AGENDA ACTION ITEM

ITEM TITLE: **5:00 PM - Scenic Corridor Review. Alpine Acres Lots 1-5 Scenic Corridor**. Harley Wilcox is requesting approval for a Scenic Corridor review placement of 5 lots (lots 1-5 of Alpine Acres Subdivision). The property is completely within the Scenic Corridor Overlay. Additional construction and materials detail has been provided.

PROJECT BACKGROUND: The applicants submitted a request for a Scenic Corridor Design review application on July 20, 2023. They are proposing to construct 5 structures and driveways within 5 lots of the subdivision. The property currently has A/RR-2.5 zoning. The property is located within the Alpine Acres subdivision and has highway frontage. There is no existing landscaping.

SITE PLAN

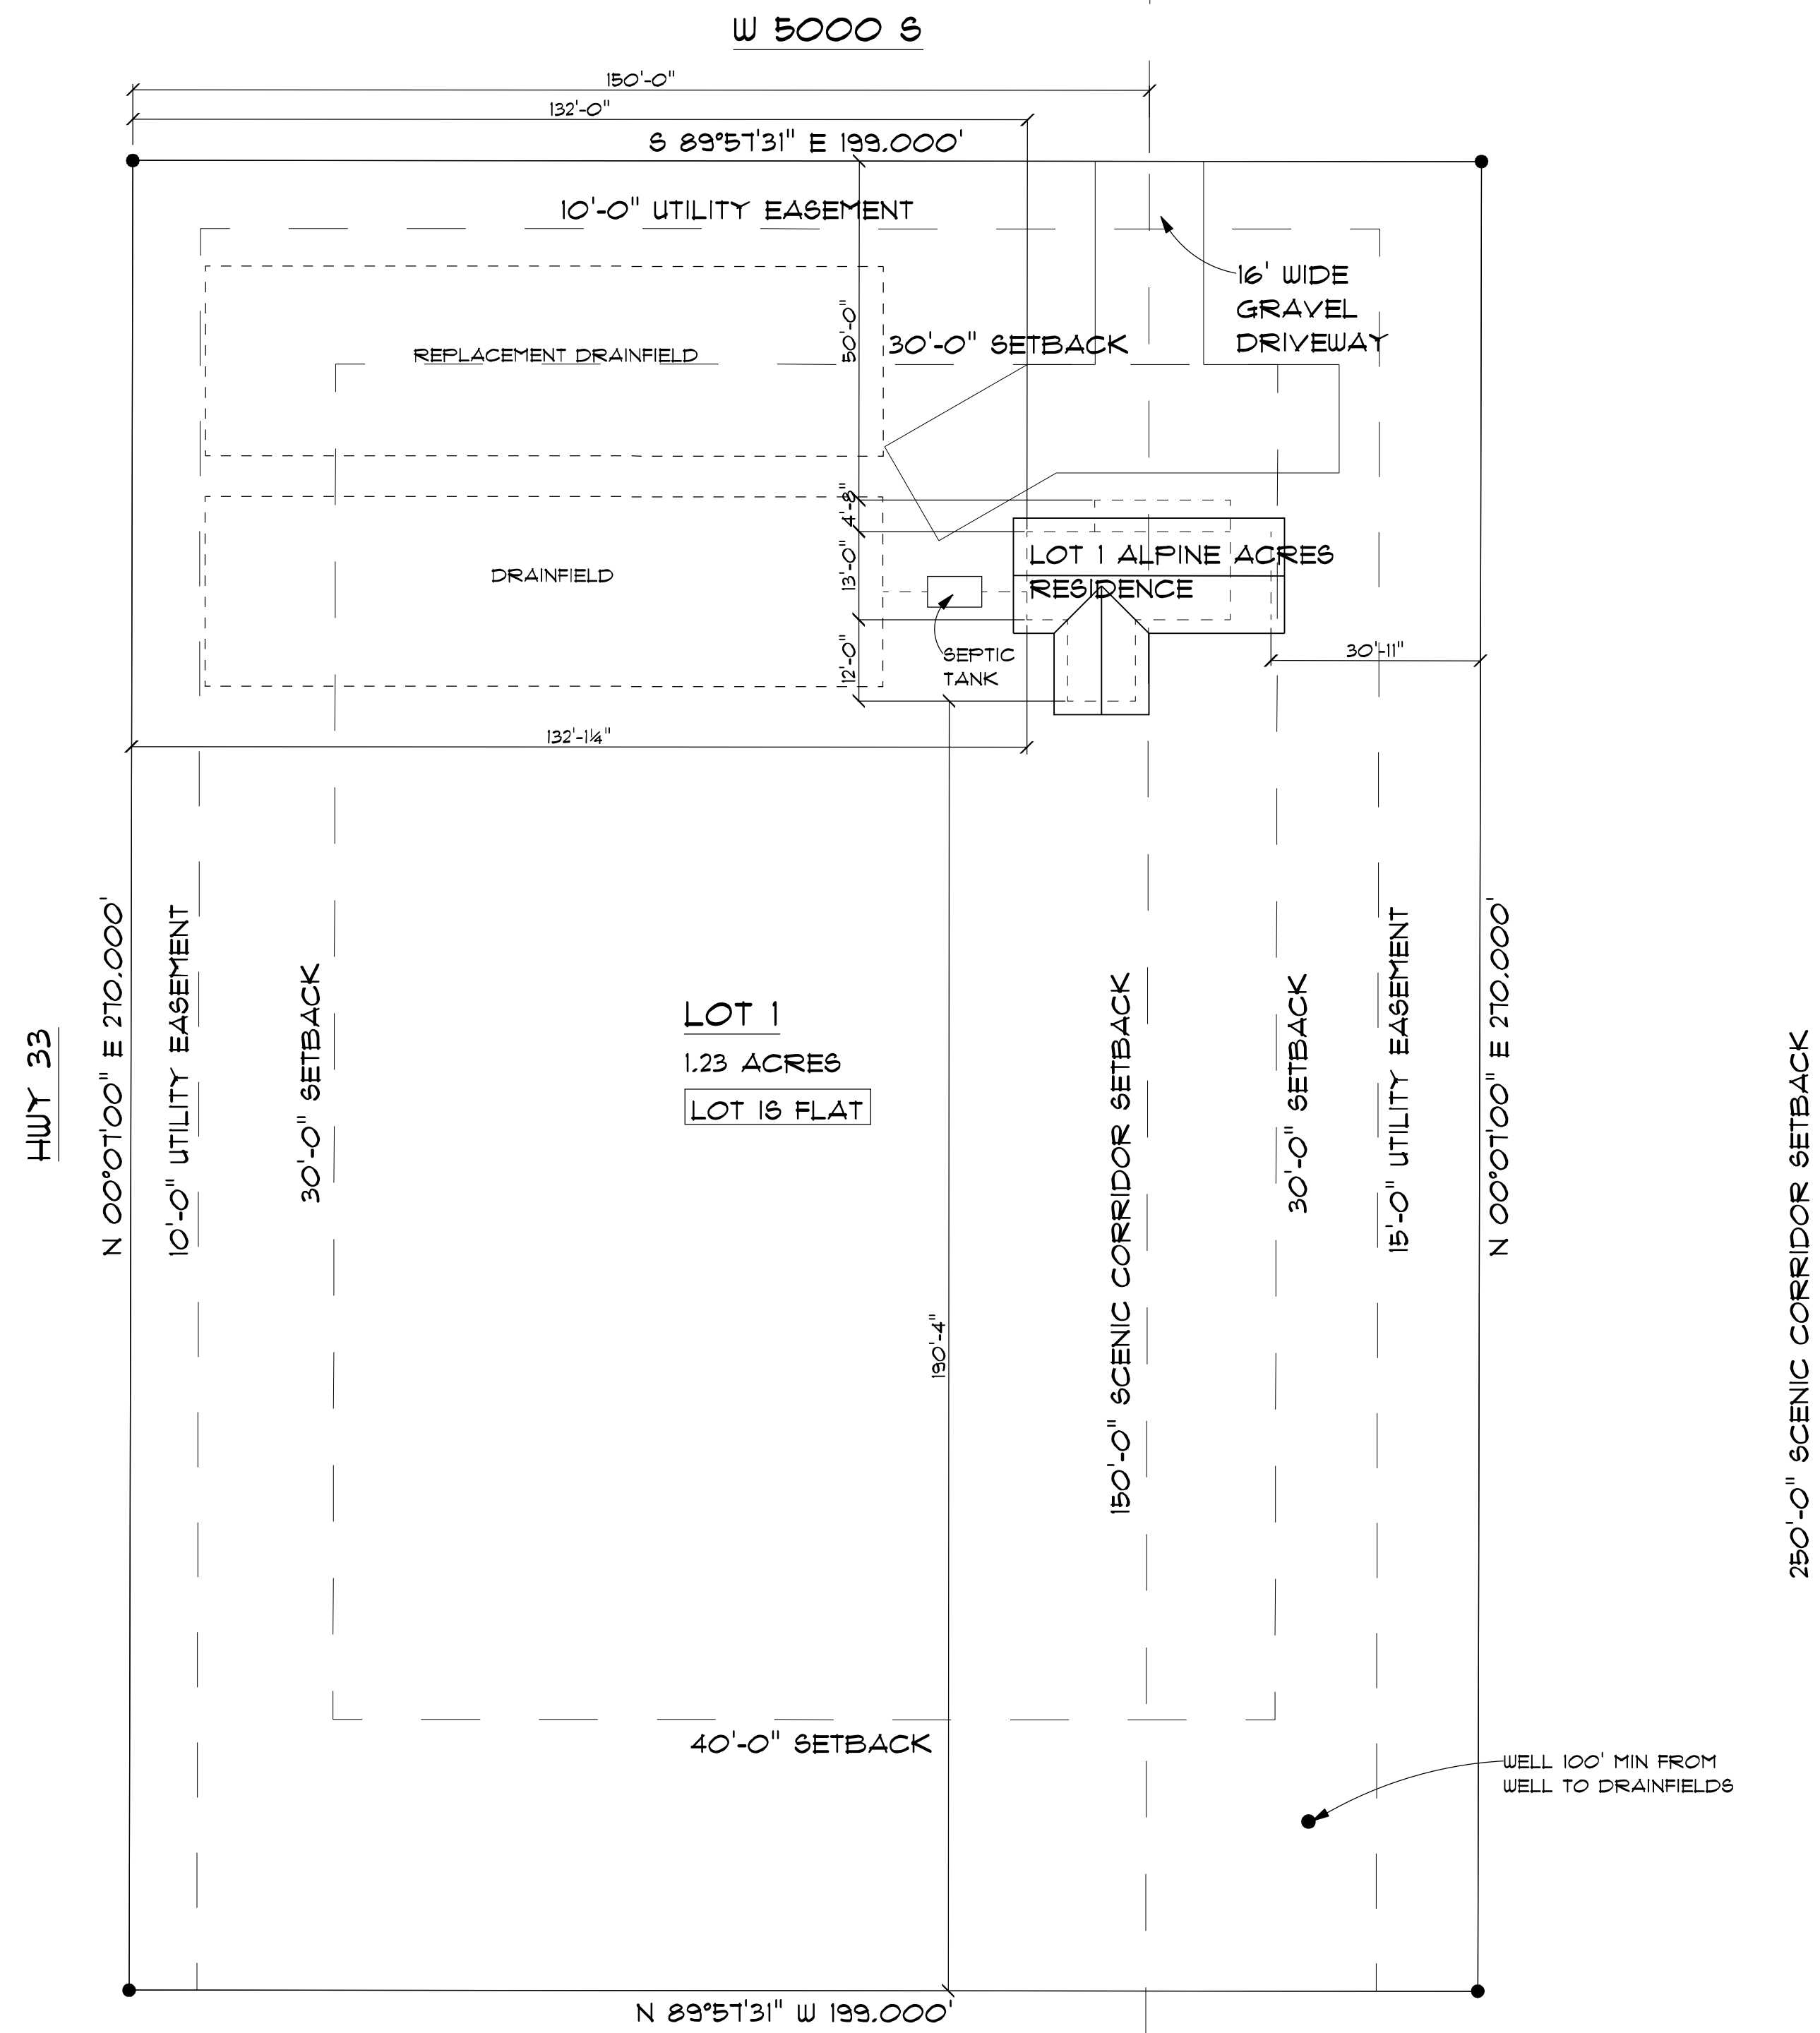
| 5-5-4 RESOURCE DEVELOPMENT STANDARDS | | STAFF COMMENTS: |
|---|--|--|
| SETBACKS | Physical development (including new buildings and existing buildings being replaced) shall be sited from the right-of-way of the state highway per Table 8 5-5-4. | <i>The proposed construction one each lot will be located at minimum 121' from Hwy 33. ADR-2.5 requires front and side setbacks of 30' and rear setbacks of 40', with which this complies. The building height is ~13'6 feet tall. This meets the requirements of the LDC.</i> |
| | Existing buildings that encroach upon the dimensions shown in Table 8 shall not perform any repairs, additions or replacements of any portion of the building that will encroach any further into the standards in Table 8 than the existing condition. | <i>Planning staff believes setbacks are reasonably set back as much as possible from the highway.</i> |

| SCREENING | Landscaping shall be used to screen the view of any resource extraction sites, outdoor storage areas, outdoor trash collection areas, satellite dishes over two (2) meters in diameter, and areas with inoperable equipment or more than four (4) inoperable cars or trucks. Required landscaping should be high altitude, native plant material, trees and shrubs | <i>There is no landscaping in place or landscaping proposed to screen construction from Hwy 33. A landscaping plan was required and the applicant provided a site plan proposing only grass.</i> |
| THERE ARE ADDITIONAL PROVISIONS FOR SATELLITE DISHES, REVEGETATION, UTILITIES, AND SIGNS. | | <i>No plans for satellite dishes or signage are indicated on the plans.</i> |

1. All structures require a Teton County Building Permit and must comply with the Teton County Building Code.
2. A landscaping plan be provided along with building permit submittal that buffers construction from Hwy 33. This will be reviewed by planning staff during building review. A CO will not be provided until the landscaping plan has been planted.
